BIKESYDNEY'S RESPONSE TO THE JOHNSTONS CREEK PARKLANDS DRAFT MASTERPLAN

We present the following recommendations in response to the Johnstons Creek Parklands Draft Master Plan - Issue F (April 2013).

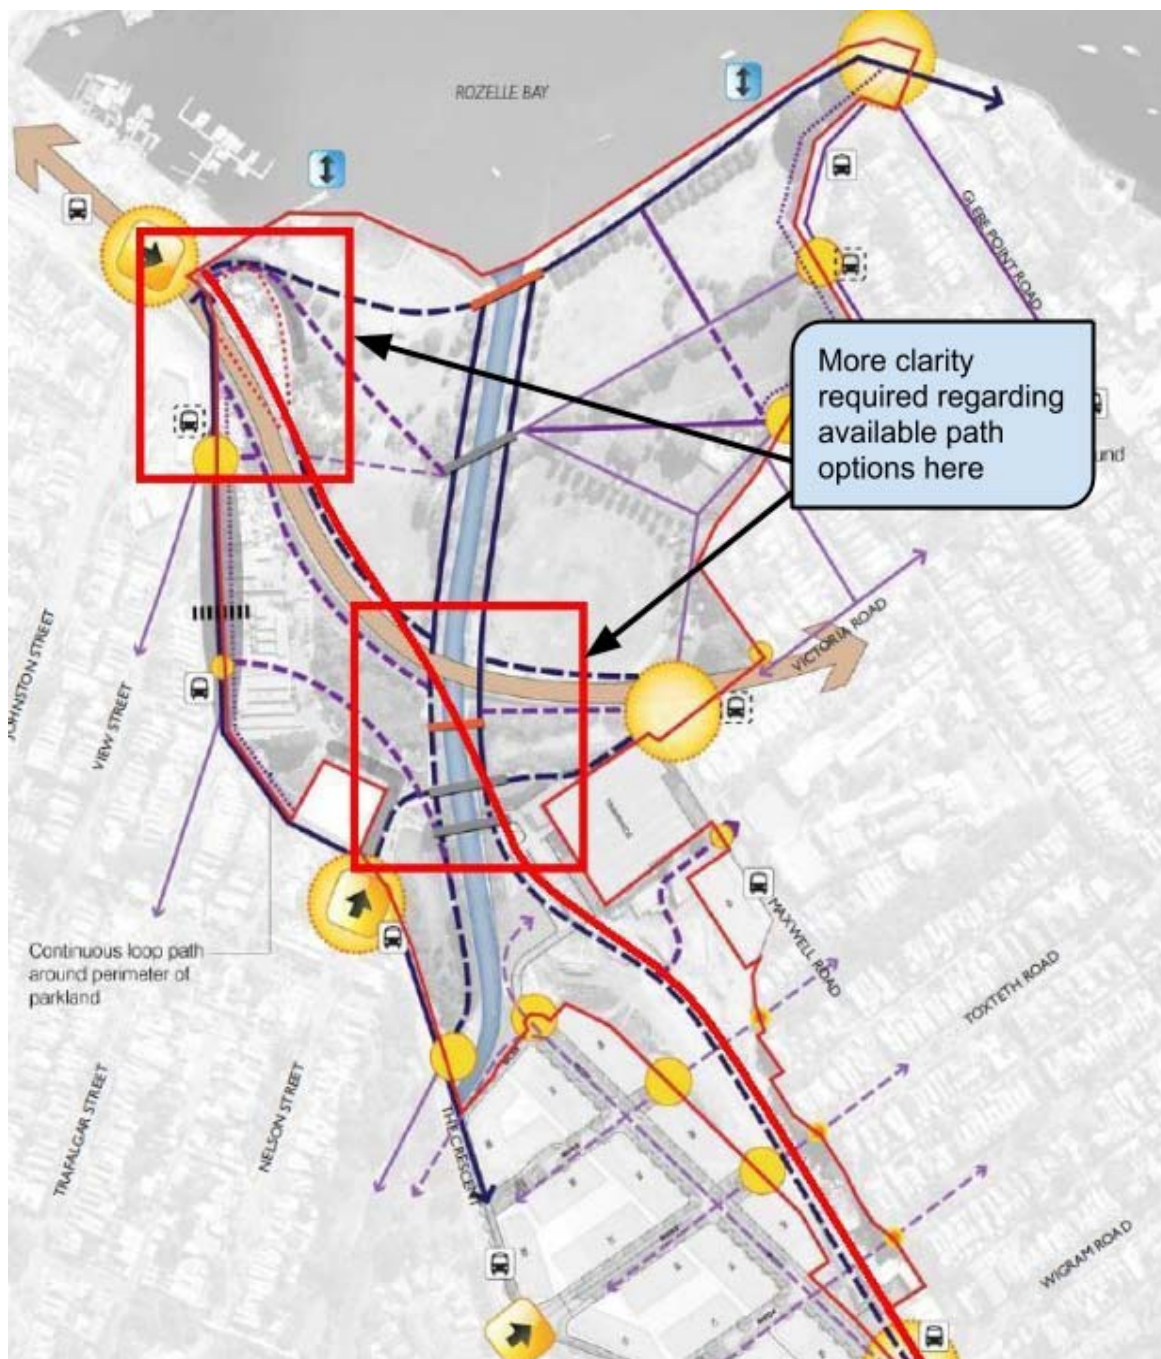
The redevelopment of the Parklands presents a critical opportunity to provide vital north-south cycling connections through and around the Parklands. Of particular importance is that a viable alternative to having to cycle as mixed traffic on The Crescent is provided as the prospect of having to do so is a barrier to a significant number of would-be cyclists.

A formal cycleway along The Crescent would alleviate the internal paths of the Parklands of a significant volume of bike commuter traffic.

Aside, the Master Plan needs to more cohesively articulate an internal north-south cycling route from the intersection of Chapman Rd/The Crescent to Ross St (see figure below) in keeping with the Section 3, Objective (k) of the Harold Park DCP which requires provision of *"...a high quality south to north separated pedestrian and cycle connection from Ross Street to Jubilee Park"*.

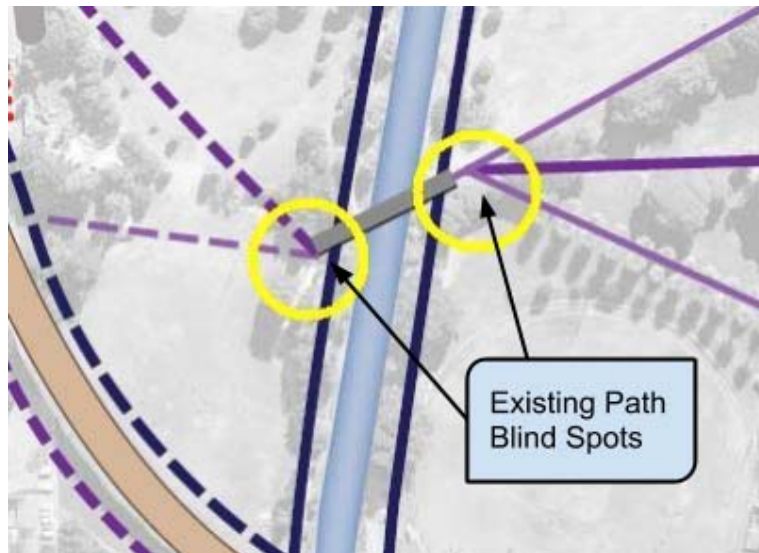
The new canal bridges must be made wide enough to accommodate mixed flows (comprising walkers, joggers, dog walkers and cyclists). It is also important that the bridge fencing be visually pervious so that the movement of kids and dogs on the bridge can be anticipated.

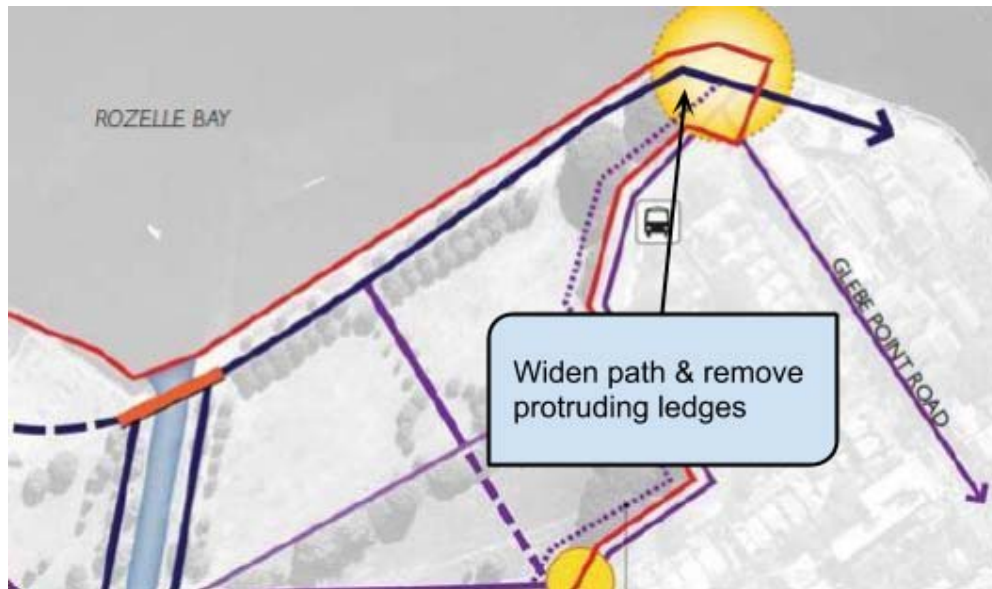
Public transport (buses and trams) stops within the Parklands must be serviced by highly-legible and well-signed cycleable paths. The Master Plan’s Transport/Access guide should be updated to feature these aspects, and the Master Plan should champion inter-modal (eg, bike+tram and bike+bus) travel.
